umtanum build
2258 15th ave w

workshop AD
Karen Kiest | Landscape Architects

design proposal

response to edge

enlarged section - looking north

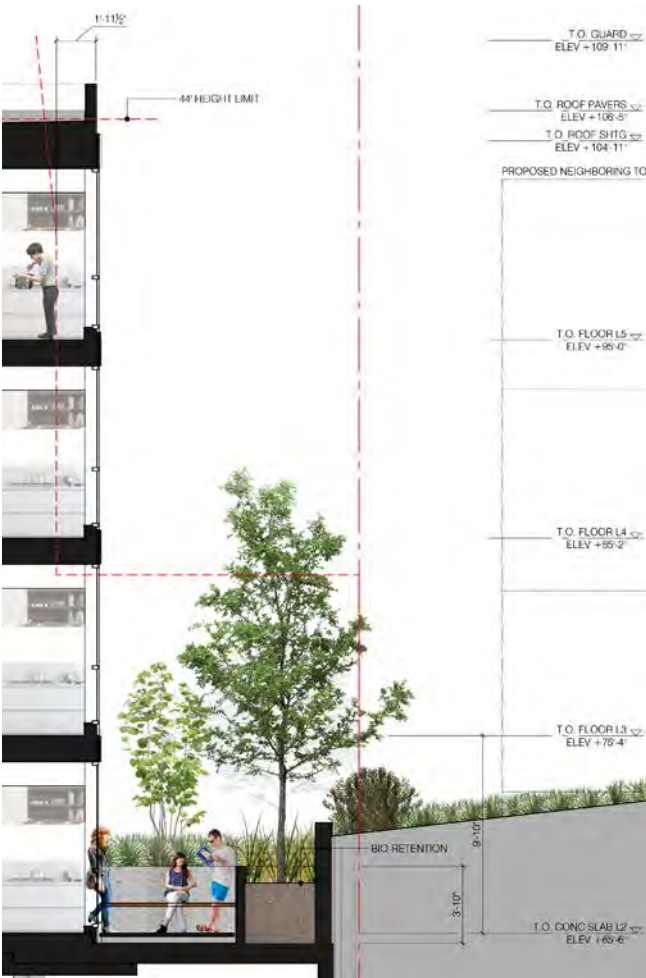
b. The Board preferred Option C due to the expanded sidewalk, creating a wider pedestrian realm along 15th Avenue West. However, the Board was concerned with how the massing relates to the residential zone (LR3) to the rear and instructed the applicant to provide a section through the building to illustrate how the landscaping and shoring wall provides an adequate transition to this residential zone. (CS1-C-2. CS2-D-3)

Applicant Response:
Floor-to-floor heights of the residential levels were reduced and the height of the street level commercial floor was increased to bring the 2nd floor levels closer to existing grade at the east property line. This creates a more natural relationship between the development and the surrounding context. Planters and retaining walls at the rear patios have been developed as stepped terraces to transition between the proposed project and the residential zone. Different types of landscaping create a variety of scales and screening between the project and the residentially zoned property to the east. Refer to landscape plans, perspective renderings and enlarged sections.

west elevation

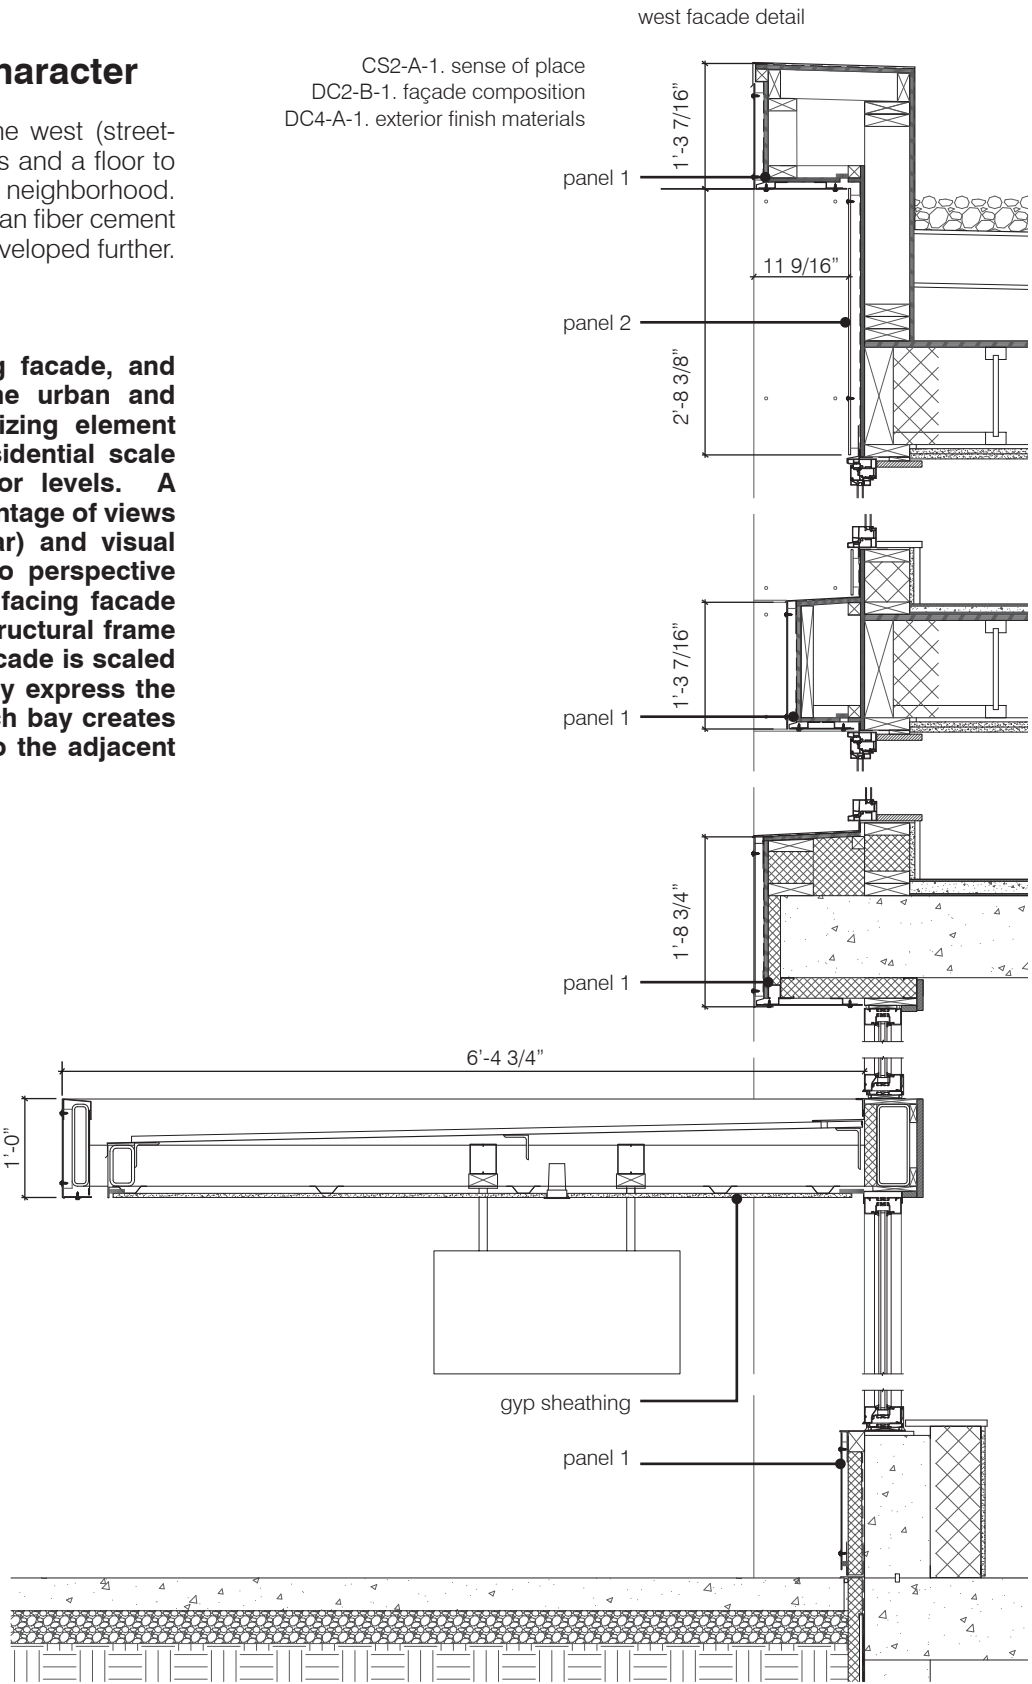
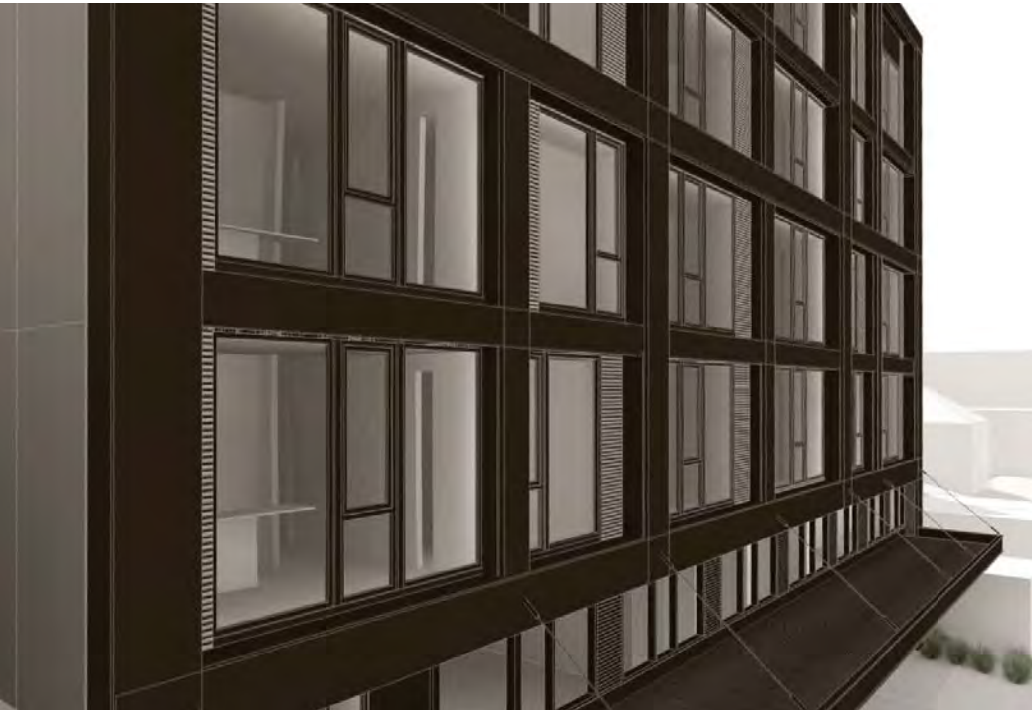
a. The Board strongly supported the design direction of the west (street-facing) façade which utilizes secondary architectural features and a floor to ceiling expression that alludes to the character of the Interbay neighborhood. The Boards supports the use of high quality materials other than fiber cement siding to strengthen this design language as the façade is developed further. (CS2-A-1, DC2-A-2, DC2-B-1, DC4-A-1)

Applicant Response:
The project maintains the depth of the street facing facade, and has been further developed to respond to both the urban and residential environments through the primary organizing element of an industrial structural frame which maintains residential scale through the articulation of walls and individual floor levels. A secondary vocabulary of glazing and louvers take advantage of views while mitigating exposure - both environmental (solar) and visual (neighbors, pedestrian and vehicular traffic). Refer to perspective renderings and rendered elevations. While the street facing facade responds to the scale of 15th Ave W. with a primary structural frame across the entire facade, the east, residential facing facade is scaled using a frame that has been modified to more strongly express the unit width. The repetition and vertical emphasis of each bay creates a scale more typical of a rowhouse, to better relate to the adjacent residential zone.

street // level 1 plan

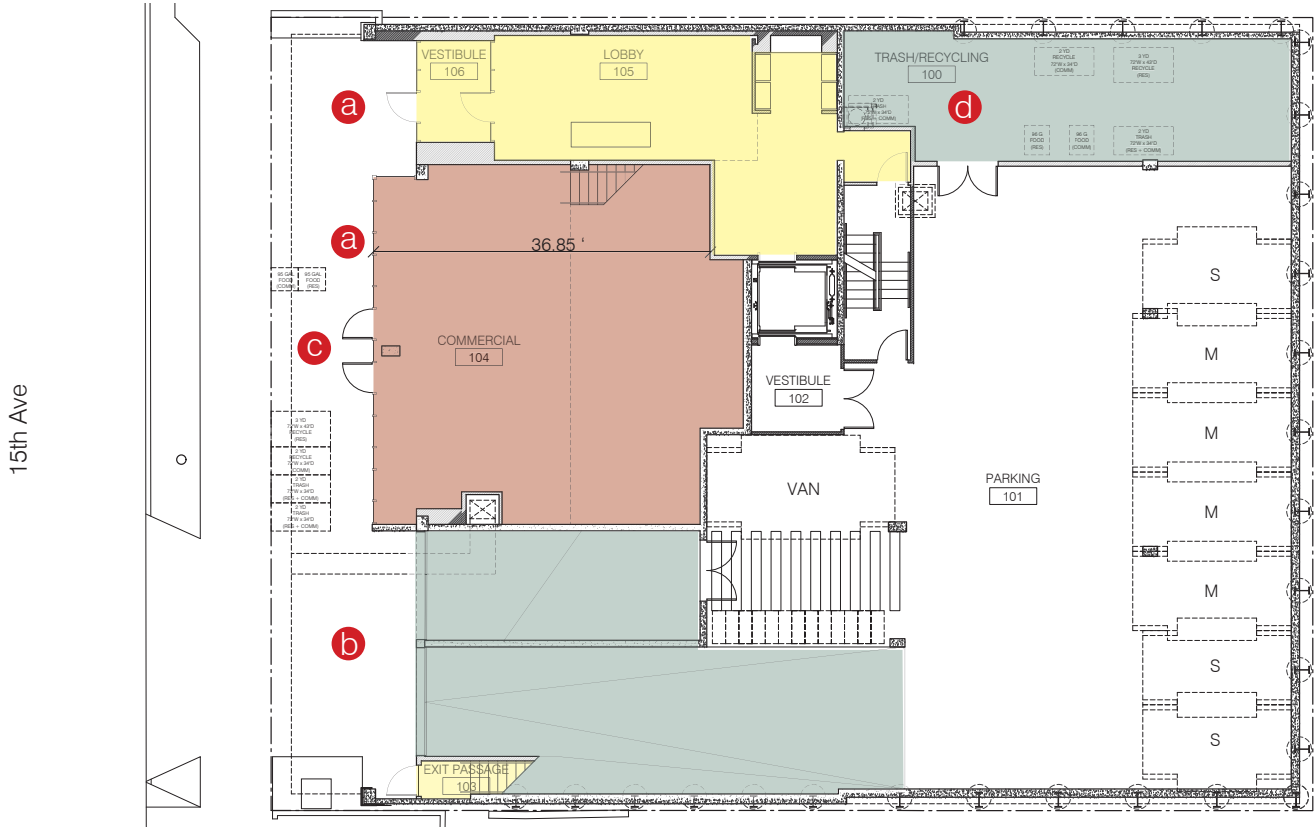
d. The Board was concerned with the depth of the commercial space and how the space interacted with the public realm. The Board recommended developing a design that increases visibility/interaction with the sidewalk while maintaining a depth that will be viable for a commercial tenant. The Board also recommended increasing the level of transparency into the commercial space. (CS2-B-2, PL2-B-3, PL3-C-2, PL3-C-3)

Applicant Response:
The depth of the commercial space has been increased to an average of 34.7 feet. Floor-to-floor height at street level has been increased to 18’-0”, allowing for a mezzanine in the commercial space. Commercial transparency/glazing has increased from 248sf to 362sf, improving visibility and interaction with the sidewalk. Refer to perspective renderings, plans, elevations and sections.

garage screen

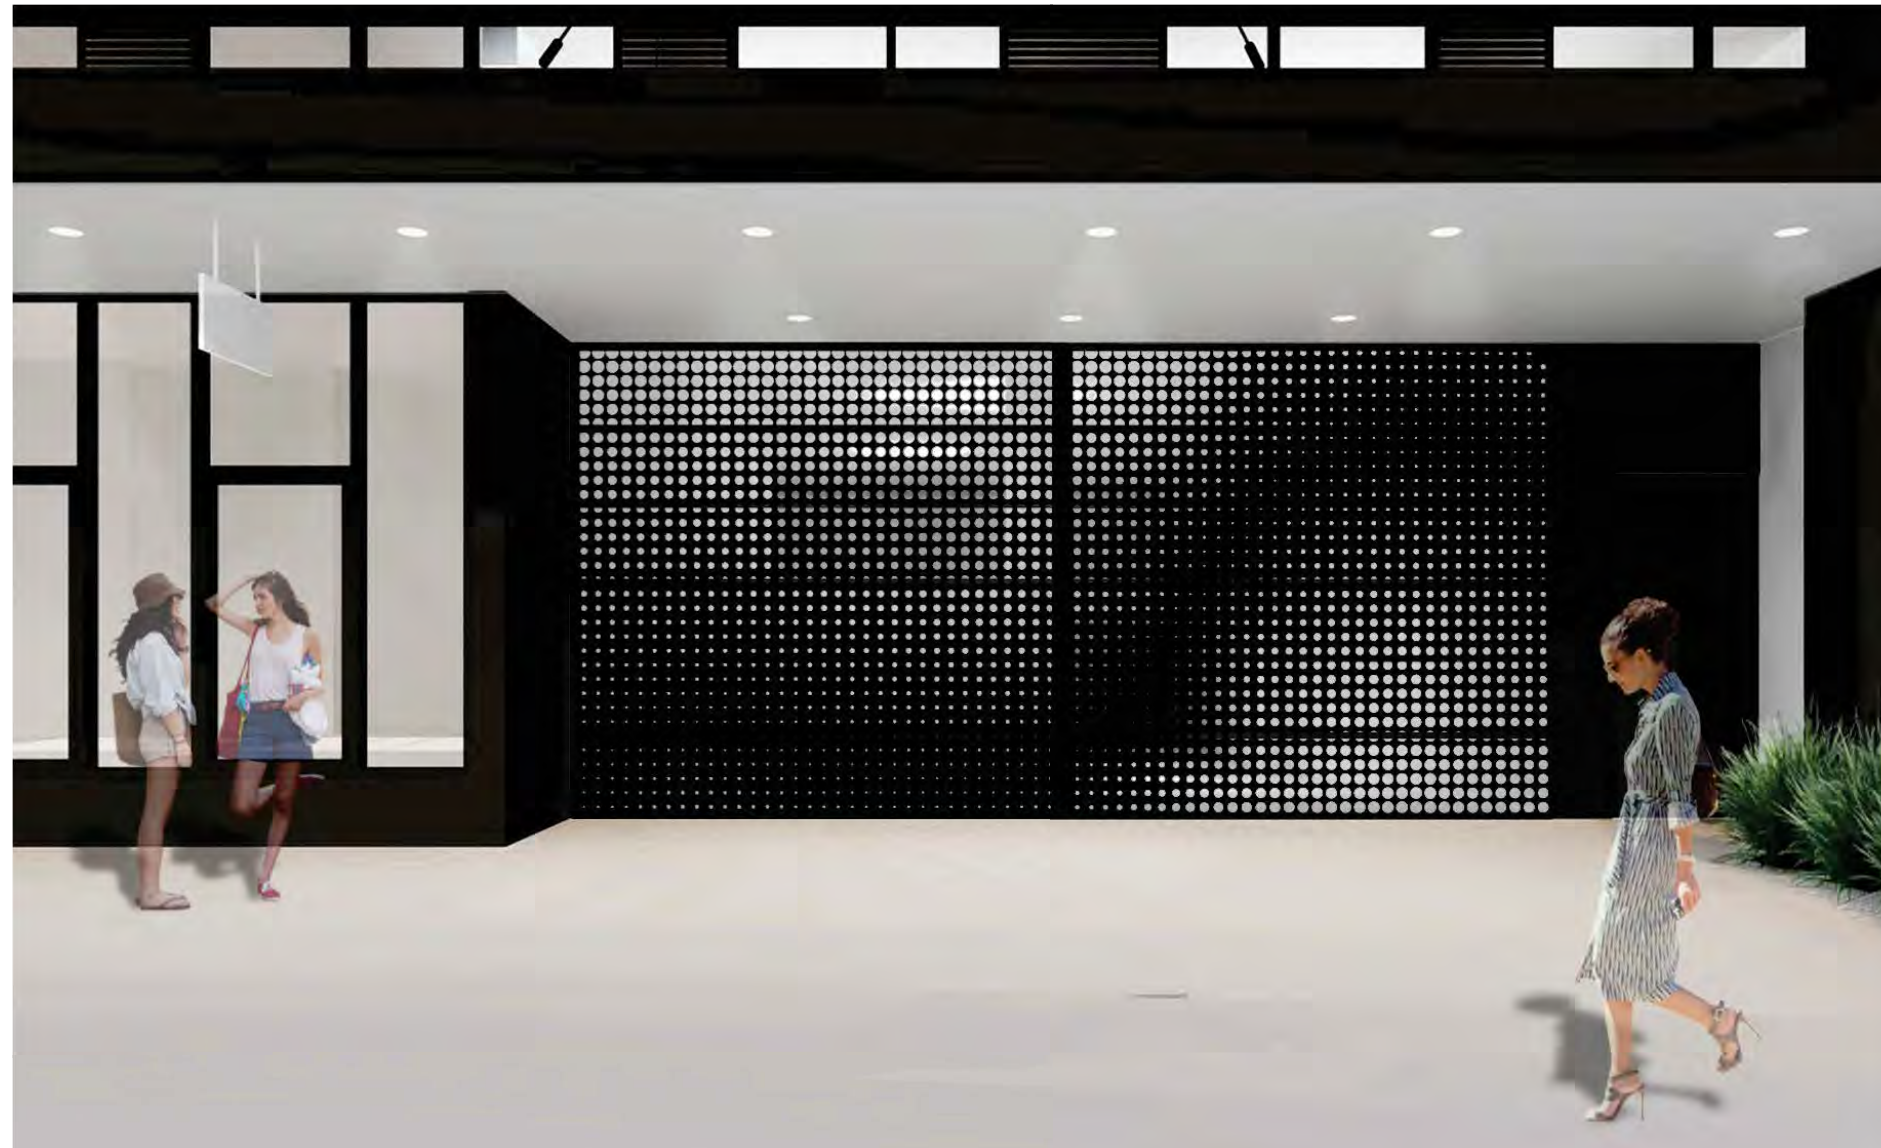
b. Access Location and Design, Visual Impacts
The Board instructed the applicant to explore methods to minimize the impact of the garage entrance and incorporate this into the full design of the structure. The Board also recommended providing more information on how the parking would function in terms of serving both the commercial and residential uses. (DC1-B-1, DC1-C-2)

Applicant Response:
The entrance and screen to the parking garage have been recessed, widening the sidewalk and creating more pedestrian space, strengthening the prominence of the commercial frontage. Above the canopy, the clerestory windows continue over the garage entry, reducing the apparent scale of the garage in the overall facade. The screen is integrated into the industrial vocabulary of the secondary architectural elements, further mitigating the impact of the parking entrance on the facade. A five foot wide landscape planter is provided at the south side of the driveway to reduce, soften and buffer the edge of the driveway. Refer to perspective renderings and plans.
